AMBLER BOROUGH PLANNING COMMISSION

1. Review the 9 N. Maple Street Sketch Plan proposing a 92 residential unit five story building with associated parking – Ambler Lakeview Development LP
APPLICANT TO DO PRESENTATION

Reference: Sketch Plan Review
Ambler Lakeview Development, L.P.
9 N. Maple Avenue, Ambler Borough and 5 N. Maple, Upper Dublin Township
Tax Parcel #01-00-02938-40-9; Block 01047, Unit 008
Tax Parcel #54-00-11581-50-6; Block 54035, Unit 014

CONCEPT PLAN D
SHEET NUMBER: 1
PROVISION 4, 04-10-2017

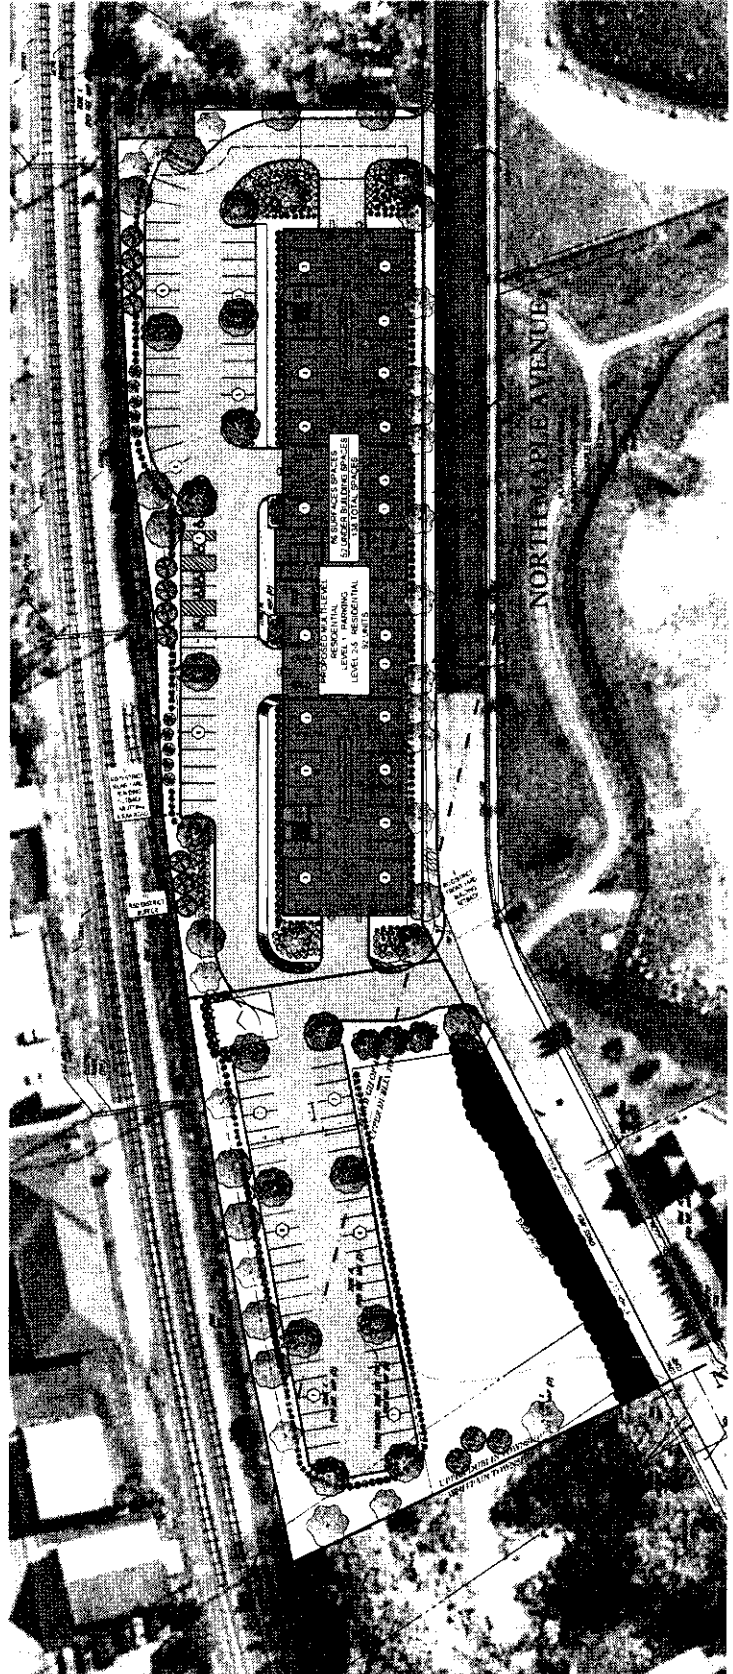
- 1. §27-412 & §27-2703.E(4)(i) & §27-2705.J – The sketch plan does not include site lighting. The applicant should provide a lighting plan that complies with the Borough lighting criteria.
- 2. §27-413 & §27-2703.E(3) & (4) – Assuming the Borough determines that the proposed use is considered a TOD Transit-Oriented Development use and based upon the current Zoning Ordinance, the proposed use will need conditional use approval.
- 3. §27-1907 & 1910.G – The proposed development is directly adjacent to the floodplain (Zone AE). Proposed grading at the site could affect the floodplain. There is the potential that a special exception would be needed. This will need to be evaluated upon submission of more detailed grading plans.

5. §27-2703.A(1)(b) – The parking spaces within the garage appear to be 9 feet by 18 feet. The dimensions shall be included on future plan submissions.

6. §27-2703.A(1)(d)1 – The parking garage setback is 10 feet when in joint use with another permitted use. The plan shows the building setback at 8 feet. We defer to the Borough Code Officer to determine if this is applicable to this proposed development.

8. §27-2703.E(4)(a)2 – The minimum lot area is 8 acres or 4 acres if the road frontage is a least 750 feet. The proposed lot is less than 3 acres.
9. §27-2703.E(4)(a)5 & §27-2705.A – The development will be required to be serviced by public water and sewer. The applicant should confirm service is available.

11. In general, the sketch plans do not include a Zoning Compliance Table. This information should be included with future submissions.
12. §27-2703.E(4)(b) – We note the following regarding the density, mix, and bulk requirements:

- a. The maximum allowable density is 35 units per acre. 48 DU/acre are proposed.
 - b. The maximum length of any building used exclusively for multifamily residential use is 250 feet. The proposed building is 365 feet

15. §27-2703.E(4)(e) – It appears that the number of parking spaces proposed (138) is compliant with the requirement (1.5 space per DU). The Applicant shall provide parking calculations to demonstrate compliance with this section.

27. §22-303.B.(5) – A sketch plan shall show significant topographical and physical features, such as floodplains, wetlands, steep slopes, woodlands and existing features. There are no existing features shown on the subject parcel.
28. §22-303.B.(6) – Proposals for control of drainage runoff shall be shown on the plan.
29. §22-310.3.A – A traffic impact study is required for this project.

30. §26-303.B.(5) – A sketch plan shall show significant topographical and physical features, such as floodplains, wetlands, steep slopes, woodlands and existing features. There are no existing features shown on the subject parcel.
31. §26-Part D – Stormwater Management. The Applicant shall show compliance with this section during further design submissions.
